### APPEAL SUMMARY

**Appeal ID:** 20816

**Project Address:** 1225 NE 2nd Ave

**Proposed use:** Activity Shelter

Fire Separation Analysis

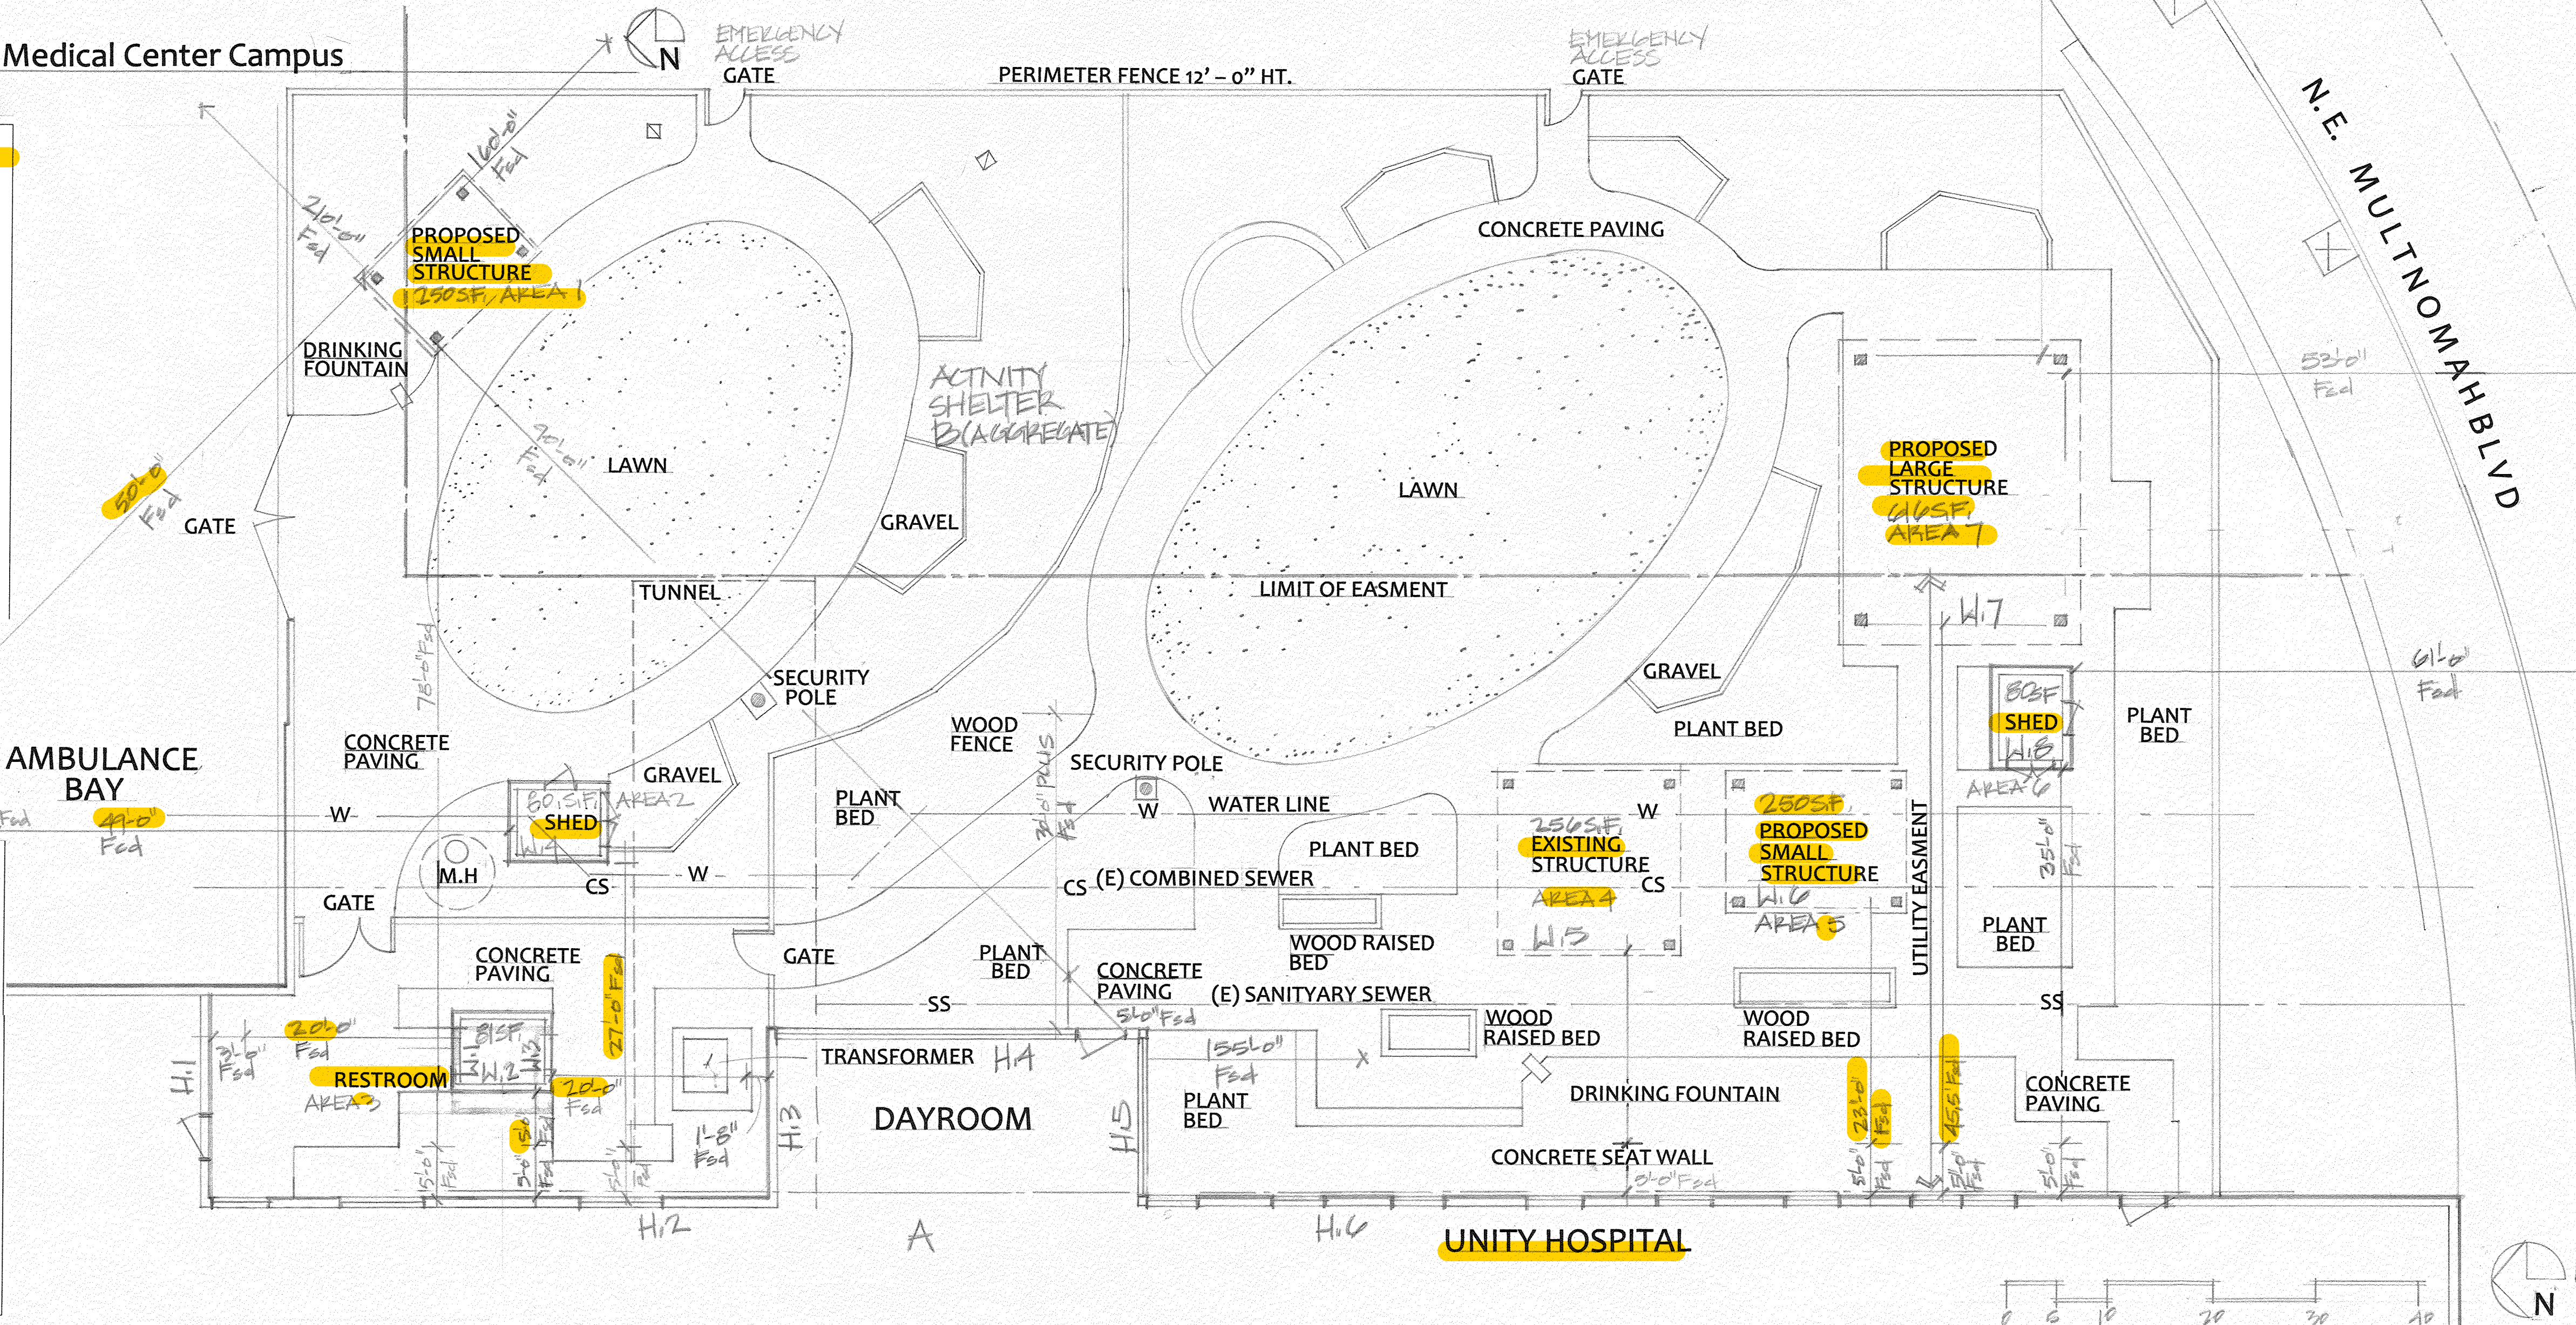
Using Section 705.3, Buildings on the Same Lot, Fire Separation Distances were analyzed to meet code requirements for both the existing hospital building and the proposed Activity Shelter. As can be seen on the attached Site Plan and in the Building Fire Separation Analysis distances between the two buildings vary, but all fire separations (fsd) distances meet code for both buildings.

As can be seen from the attached site plan and building fire separation analysis the closest distance between the new Activity Shelter, Area 3, and the existing Hospital Building is 10 feet with a fire separation distance of 5 feet from each building. The existing Hospital Building wall already meets the fire rating requirements based on this distance, the wall section, W.2, of the Activity Shelter meets the code requirement of 1-hour rating for exterior walls with protection from both sides and no openings.

All other fire separation distances between the Activity Shelter and the Hospital Building, and vice versa meet the requirements of Table 601, 602, 705.8 and Sections 705.5, 705.8 and 705.8.4, see attached site plan and analysis.

**Omission of sprinkler installation in I-3 structure: Granted provided the activity shelters and toilet room are classified as B, toolsheds as S1 and comply with exterior wall rating and opening requirements to be confirmed as part of plan review.**
